**REZONING, PUD &
SUBDIVISION STAFF REPORT**

Date: May 19, 2005

Cypress Equities Subdivision

6575 Airport Boulevard
(South side of Airport Boulevard, 2/10 mile± West
of Hillcrest Road).

SITE PLAN

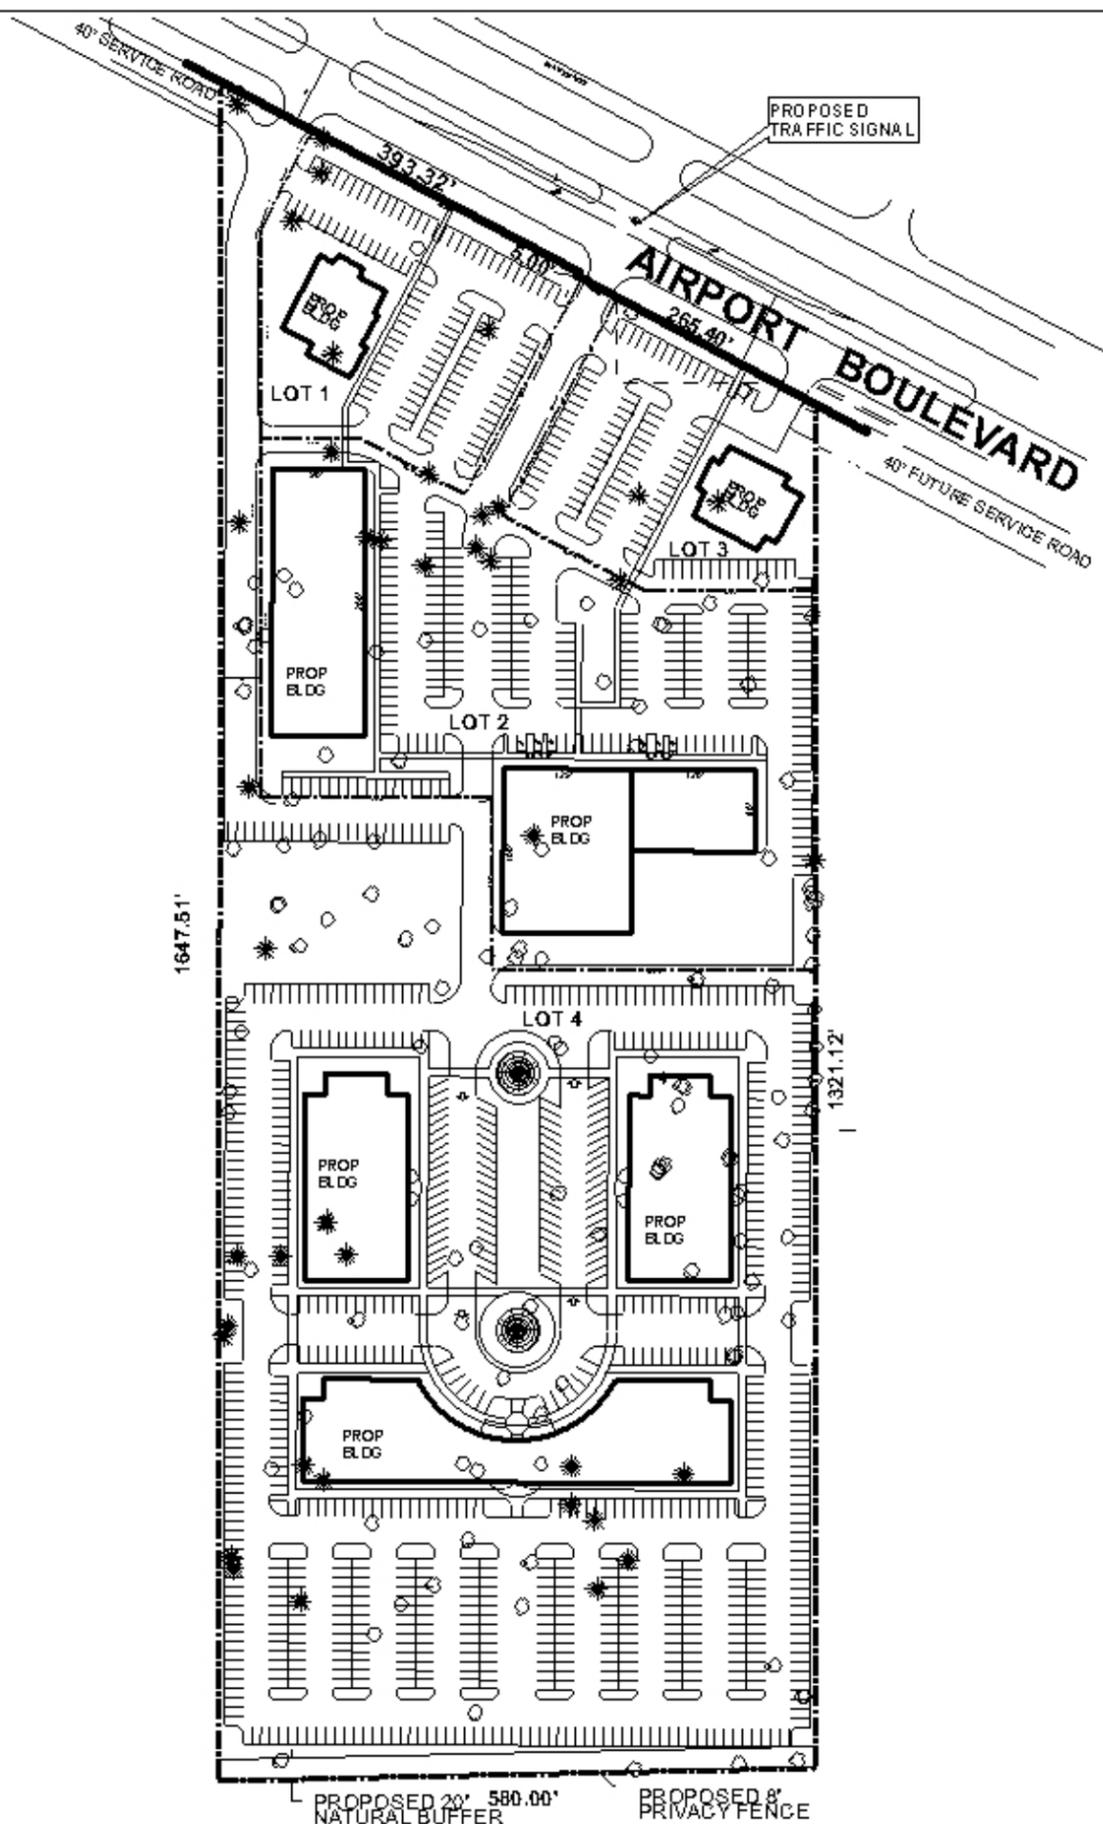
The site is located on Airport Boulevard, a major street on the city's Major Street Plan; therefore, access to Airport Boulevard is a concern. The plan as submitted indicates three access points to Airport Boulevard, one of which will require a new median cut and signalization. A fourth access point to the site is from the service road adjacent to the West. Based upon comments from the Traffic Engineering Department, additional modifications to the existing median cut (West side of the site) will be necessary as a result of this development). All of these improvements should be completed prior to the issuance of any Certificates of Occupancy within the proposed development.

A viable alternative to some of the median modifications that would be necessary may be the continuation of the existing service road and service road rights-of-ways to the East and West. This would allow the main entrance and median cut as proposed, but may not necessitate the additional median modifications if slip ramp access points are provided at the East and West sides of the development.

The plan appears to meet the general locational requirements for PUD approval. However, as submitted, the plan does not reflect the provision of buffering where the proposed development abuts residential properties (along the South property line and a portion of the east property line). Therefore, if approved, the provision of an 8' privacy fence should be required.

With regard to the proposed subdivision, two of the four lots are "flag" lots. The Subdivision Regulations state that the depth of a lot should be no more than three and one-half times the width of the lot. While the "flag" lots technically exceed that recommendation, PUD approval will allow the development to function as a single building site. Therefore, a waiver of Section V.D.3 would be appropriate. With that waiver, the plat meets the minimum requirements of the Subdivision Regulations.

Planned Unit Development: 1) intersection improvements (including signalization) and median modifications, as recommended by Traffic Engineering, to be completed prior to the issuance of any Certificates of Occupancy; 2) completion of the rezoning and subdivision processes; 3) provision of an 8' privacy fence along the South and East property lines, where the site abuts residential properties; and 4) full compliance with all municipal codes and ordinances.

Subdivision: With a waiver of Section V.D.3, the plat will meet the minimum requirements of the Subdivision Regulations and is recommended for Tentative Approval, subject to the following conditions: 1) intersection improvements (including signalization) and median modifications, as recommended by Traffic Engineering, to be completed prior to the issuance of any Certificates of Occupancy; and 2) development limited to the accompanying PUD.
